Form 3160-5
(August 2007)UNITED STATES
DEPARTMENT OF THE INTERIOR
BUREAU OF LAND MANAGEMENTFORM APPROVED
OMB No. 1004-0137
Expires: July 31, 2010**SUNDRY NOTICES AND REPORTS ON WELLS**
Do not use this form for proposals to drill or to re-enter an abandoned well. Use Form 3160-3 (APD) for such proposals.5. Lease Serial No.
NMNM0404441

8. Well Name and No.
BARCLAY 11H FED 19. API Well No.
30-015-2541910. Field and Pool or Exploratory Area
LIVINGSTON RIDGE; SOUTH11. Country or Parish, State
EDDY CO, NM**12. CHECK THE APPROPRIATE BOX(ES) TO INDICATE NATURE OF NOTICE, REPORT OR OTHER DATA**

TYPE OF SUBMISSION	TYPE OF ACTION			
☒ Notice of Intent	☐ Acidize	☐ Deepen	☐ Production (Start/Resume)	☐ Water Shut-Off
☐ Subsequent Report	☐ Alter Casing	☐ Fracture Treat	☐ Reclamation	☐ Well Integrity
☐ Final Abandonment Notice	☐ Casing Repair	☐ New Construction	☐ Recomplete	☐ Other _____
	☐ Change Plans	☒ Plug and Abandon	☐ Temporarily Abandon	
	☐ Convert to Injection	☐ Plug Back	☐ Water Disposal

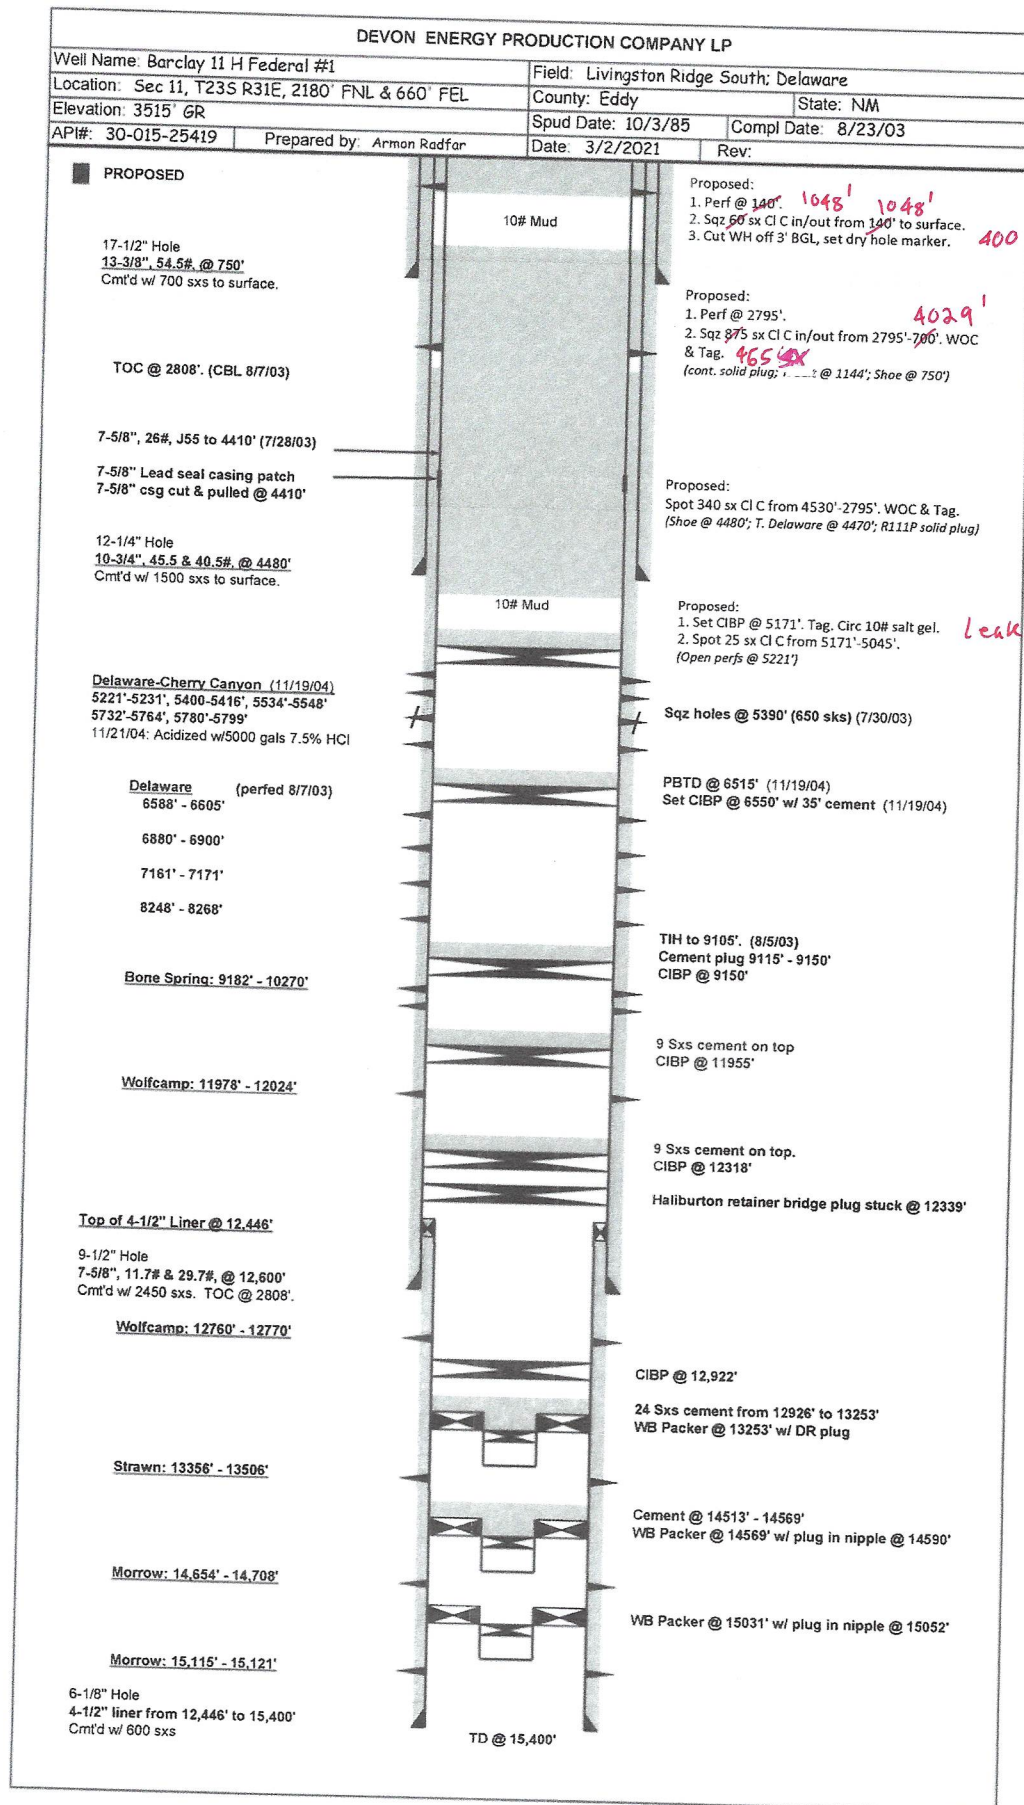
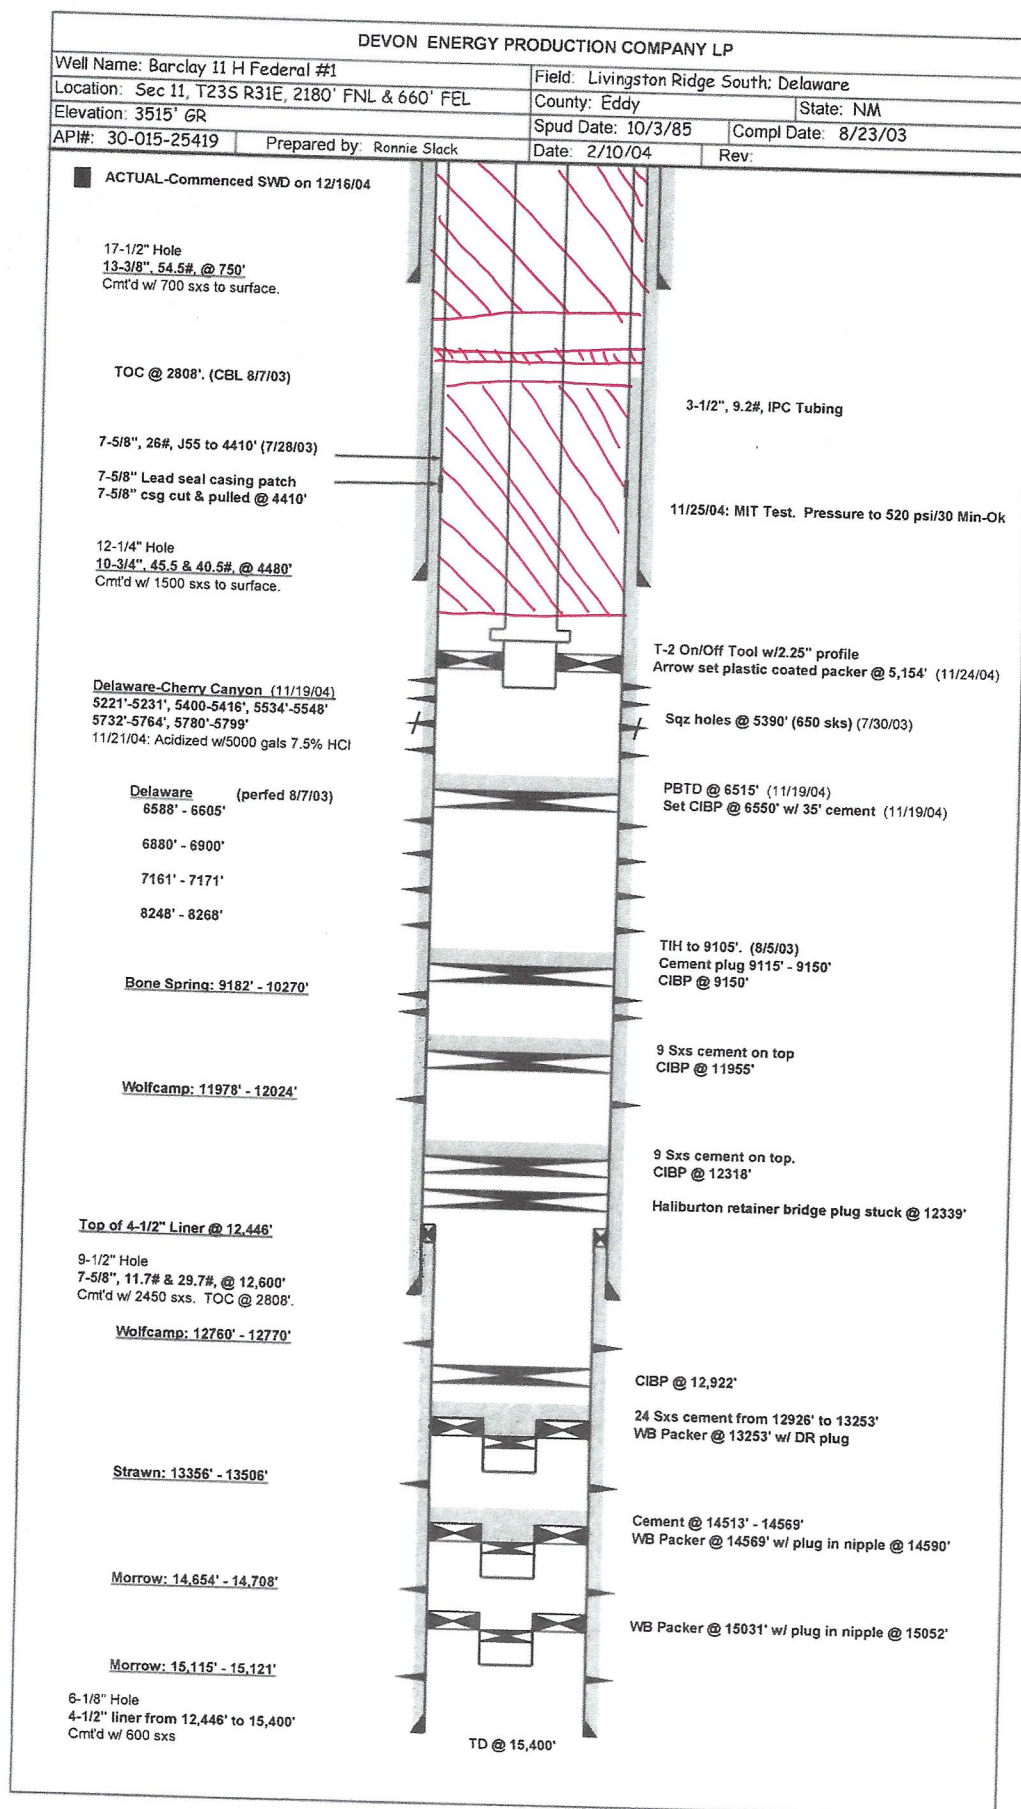
4. Perf @ 2795'. Sqz 875 sx CI C in/out from 2795'-700'. WOC & Tag. (cont. solid plug; T. Salt @ 1144'; Shoe @ 750') (2795' - 4029') 465 sx (In/Out)

6. Cut WH off 3' BGL, set dry hole marker. (1045' - surface) 400 sx (In/at)

*Verify @ surface***APPROVAL SUBJECT TO
GENERAL REQUIREMENTS AND
SPECIAL STIPULATIONS
ATTACHED**
